Service Bulletin

Bulletin No. 2005-61
CMD 2005-01

AIR INTAKE SUPPORT SCREEN

11823

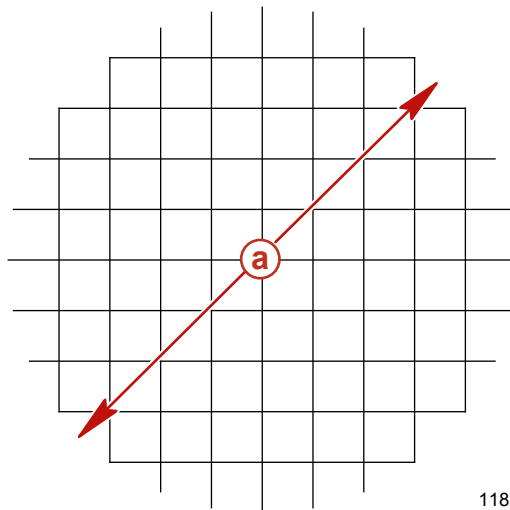
The air intake support screen, (part number 853215), for the 7.3L D-Tronic diesel engine is no longer available (NLA) as a service part.

If this part requires replacement, it can be made to the specifications below from galvanized steel screen material.

1.15 mm (0.045 in) galvanized steel, 12.7 mm (1/2 in) mesh screen

a - 12.7 cm (5.0 inches) diameter
